Docket Item #14  
ENCROACHMENT #2003-0010

Planning Commission Meeting  
May 4, 2004

**ISSUE:** Consideration of a request to encroach by 4 feet into right-of-way with fencing, columns or a wall for 34 lots.

**APPLICANT:** Potomac Greens Associates LLC

*Typical Front Yards*

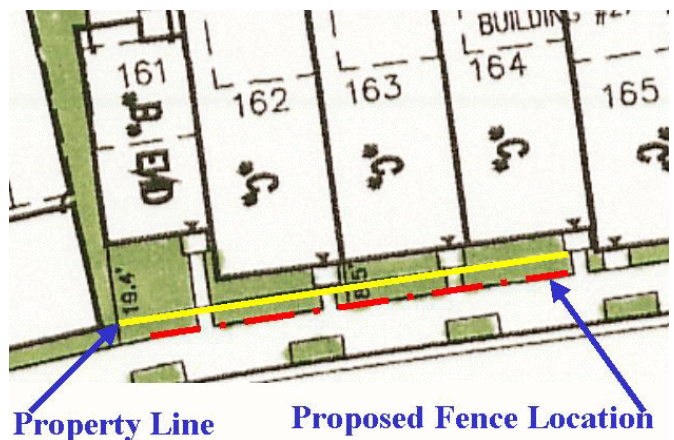
A concern of staff is that provision of fences will detract from the front yard open space and that the fences will visually narrow the width of the adjoining public sidewalks. In addition, staff was initially concerned that:

- the fences would create a precedent for other townhouses to request encroachments to permit fencing;
- the fences would visually and physically narrow the width of the adjoining public sidewalks; and
- the fences would reduce the visual open space provided by the front yards.

To address the concern regarding other townhouses requesting encroachments, staff is recommending (and the applicant has agreed) to prohibit fencing for units other than those installed by the developer. To ensure that the fences will not obstruct the width of the sidewalk, a condition of approval is that the fences must be located 10-12 inches from the sidewalk. To address the

concern regarding preservation of the visual open space of the front yards, the applicant has worked with staff to propose open wrought iron fences. In addition, the height of the fences has been limited to approximately 2-3 ft. tall. The Potomac Yard Urban Design Advisory Committee (PYDAC) has reviewed the application and recommends approval.

*One of Several Proposed Fence Styles*

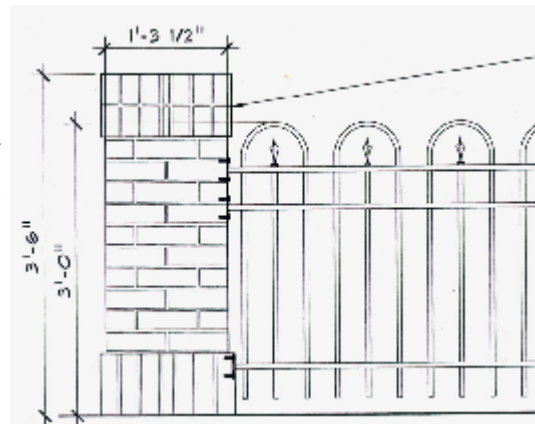
Staff believes the fences will add visual interest and variety at the pedestrian level similar to the characteristics of the traditional neighborhoods of Old Town and Del Ray, the models for Potomac Yard. With the limited amount of encroachments and conditions to ensure adequate sidewalk widths, and the height of the fences staff recommends approval.
